**THE  
NATIONAL  
BOARD**  
OF BOILER AND  
PRESSURE VESSEL  
INSPECTORS

# **NATIONAL BOARD SUBCOMMITTEE INSTALLATION**

## **MINUTES**

Meeting of July 14<sup>th</sup>, 2021  
Cincinnati, OH

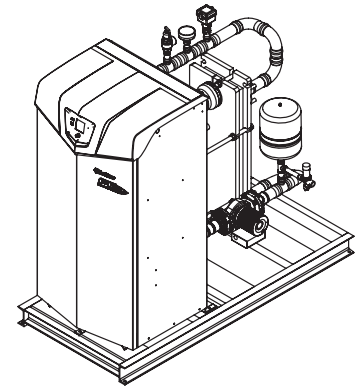
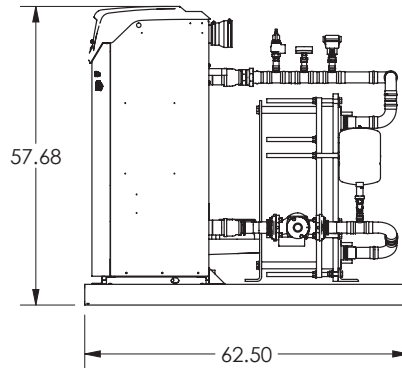
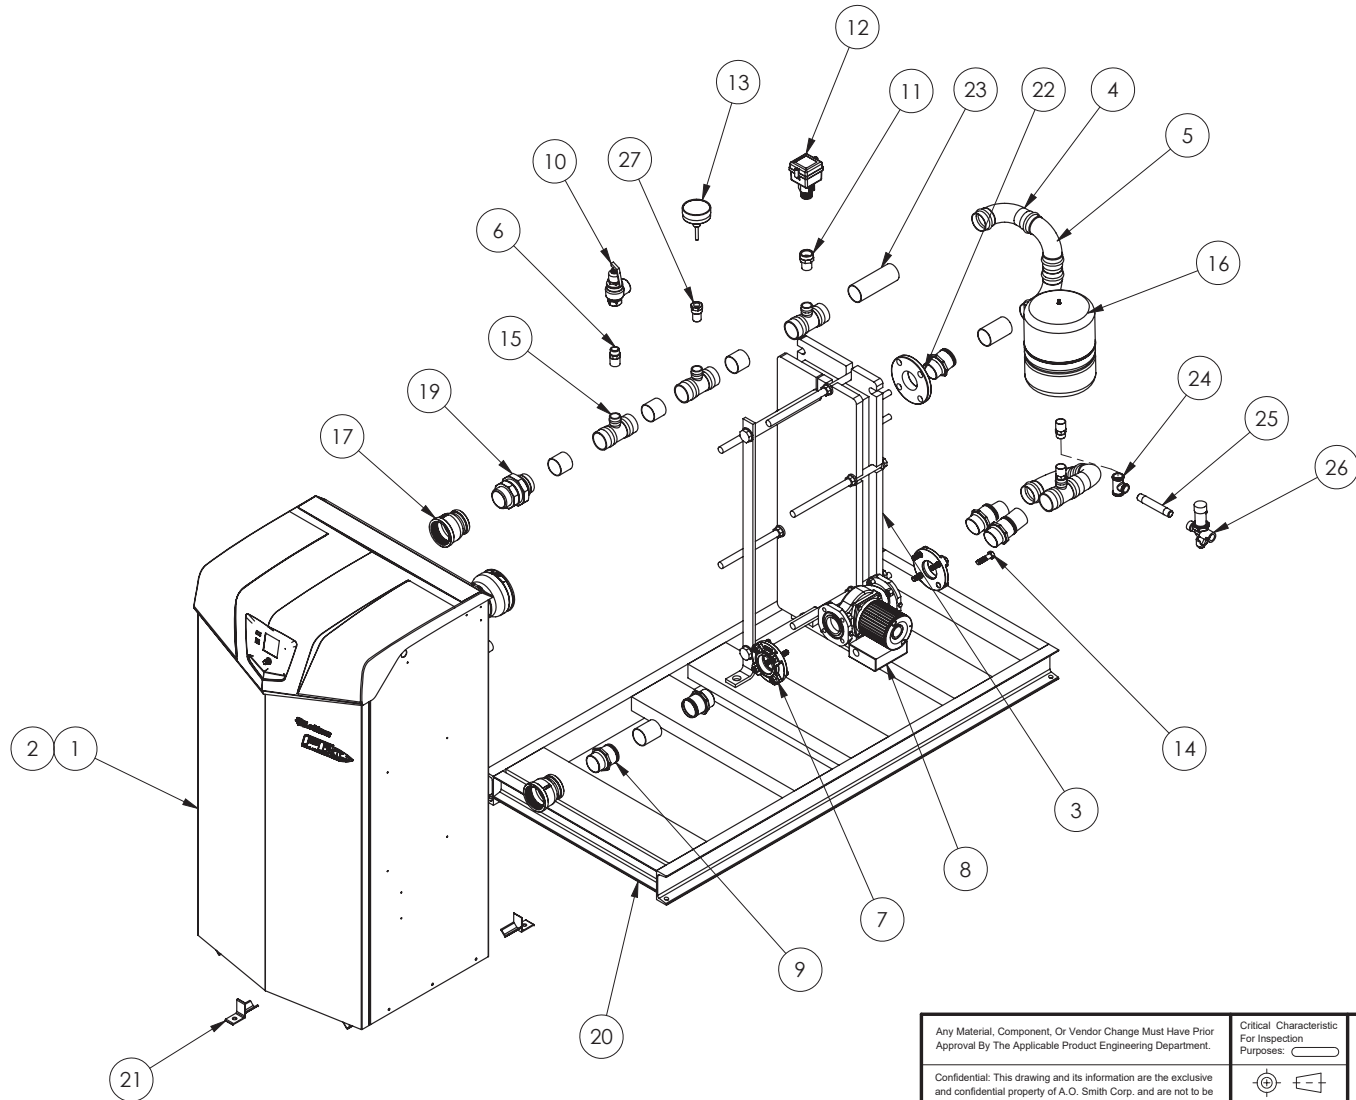
Yes, this is a package that we build. Attached is a drawing that may be a little more clear.

Now if the plate and frame heat exchanger were to be serviced, that would connect to the primary pool loop. We provide instructions to install stop valves between the plate and frame heat exchanger and the primary loop so the heat exchanger can be serviced without draining the system.

Jeff, if this is a package that Lochinvar builds is it possible to see the drawing in PDF of how it is piped? Also in reviewing the IOM, the instructions on servicing or draining the boiler/heater is not real clear.
